ADA Curb Ramp New Construction Inspection Form (Parallel)

Nw 314th ave

24952.54

Nw. Kaybern st.

PARALLEL RAMP (PL)

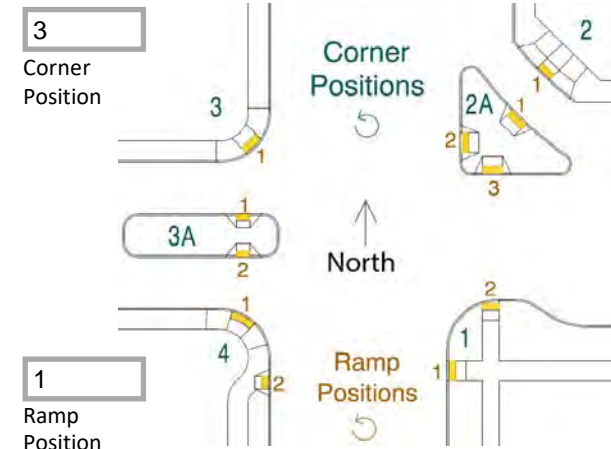
4.8 $\leq 2.0\%$ ☐ $> 2.0\%$ ☒

2.4 $\leq 2.0\%$ ☐ $> 2.0\%$ ☒

N Y ☐ N ☒

4.7 $\leq *$ ☐ $> *$ ☒

4.3 $\leq |5.0\%|$ ☐ $> |5.0\%|$ ☒

13.5 $\leq 8.3\%$ ☐ $> 8.3\%$ ☒

4.8 $\leq 2.0\%$ ☐ $> 2.0\%$ ☒

4.15 $\geq 4.0'$ ☐ $< 4.0'$ ☒

4.95 $\geq 4.0'^{*1}$ ☐ $< 4.0'^{*1}$ ☒

No detectable warning,
